Location of Construction: <i>55 VETERANS ST. PEAKS ISLAND</i>		Owner: <i>STEVE & KIM MAC ISAAC</i>		Phone: <i>773-3527</i>		Permit No: 970027 PERMIT ISSUED Permit Issued: JAN 4 1997 CITY OF PORTLAND Zone: <i>IR-2</i> CBL: <i>85-C-1</i>	
Owner Address: <i>169 WARWICK ST PORTLAND</i>		Leasee/Buyer's Name:		Phone:			<div style="border: 1px solid black; padding: 5px;"> PERMIT ISSUED JAN 4 1997 CITY OF PORTLAND </div>
Contractor Name:		Address:		Phone:			
Past Use: <i>SUMMER COTTAGE</i>		Proposed Use: <i>SUMMER COTTAGE</i>		COST OF WORK: <i>\$10,000</i>			PERMIT FEE: <i>\$ 70.00</i>
				FIRE DEPT. <input type="checkbox"/> Approved <input type="checkbox"/> Denied		INSPECTION: Use Group: <i>R3</i> Type <i>5B</i> <i>BOC # 96</i>	
Proposed Project Description: <i>REBUILD EXISTING STRUCTURE INCLUDING NEW ELECTRICAL AND PLUMBING AND ADD NEW 16' x 12' DECK.</i>		Signature:		Signature: <i>[Signature]</i>		Zoning Approval: <i>ok</i> <i>1/6/97</i> Special Zone or Reviews: <input type="checkbox"/> Shoreland <i>NO</i> <input type="checkbox"/> Wetland <input type="checkbox"/> Flood Zone <i>NO</i> <input type="checkbox"/> Subdivision <input type="checkbox"/> Site Plan maj <input type="checkbox"/> min

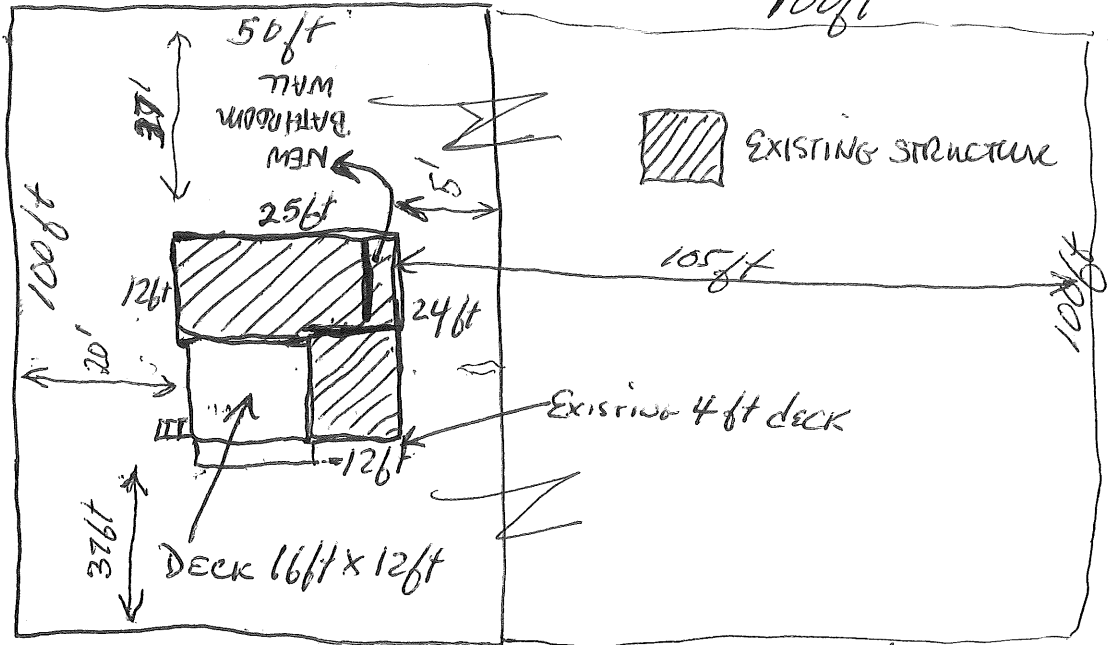
Front Yard - 25' req - 20' shown → is filled in for existing house which is same set back

Side Yard - 20' req 37' shown

shows AS part of adjoining lot
